Summary of Comments Received from the March, 2014 Circulation

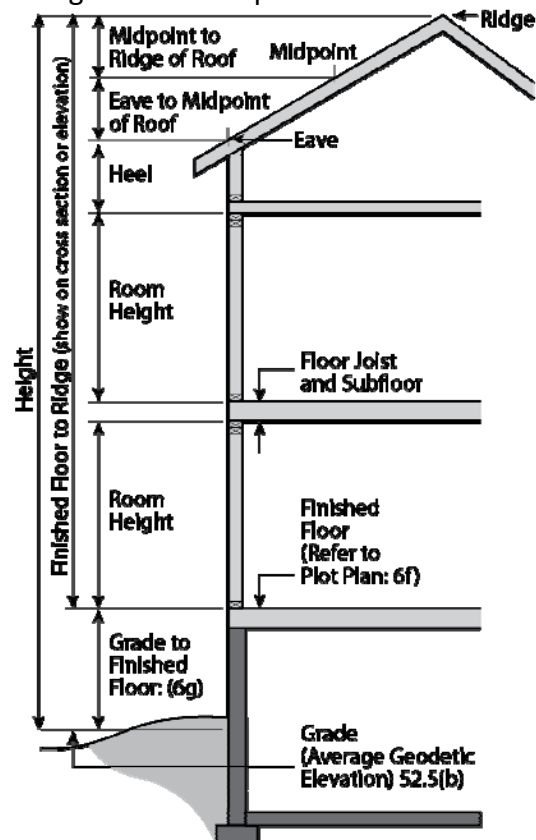
14 metres and four storeys with a pitched roof is not an achievable building form. In reviewing typical building designs for a four-storey pitched roof product, it was determined that the physical building requires 17 metres in height (depending on the direction of the gable, and how wide the building is).

Typical building sizes were examined for ground-oriented dwellings, and it was determined that a ten metre maximum height is sufficient for the distance between average grade elevation and the eave line, and 2.4 metres is sufficient from the eave line to the top of the structure.

Increase the maximum height in RF6 and RA7 from 14 metres to 16 metres (plus the height ‘bonus’ proposed in Section 52) for an effective height of 17 metres. Keep the same maximum height in ground oriented zones that allow single detached as a permitted use, including the Mature Neighbourhood Overlay, but change the height ‘bonus’ from 1.5 metres to scale with the pitch of the roof, and to allow a third storey for flat-roof buildings. Consider increasing the maximum height in zones typically applied to greenfield developments (i.e. RSL, RPL, RMD).
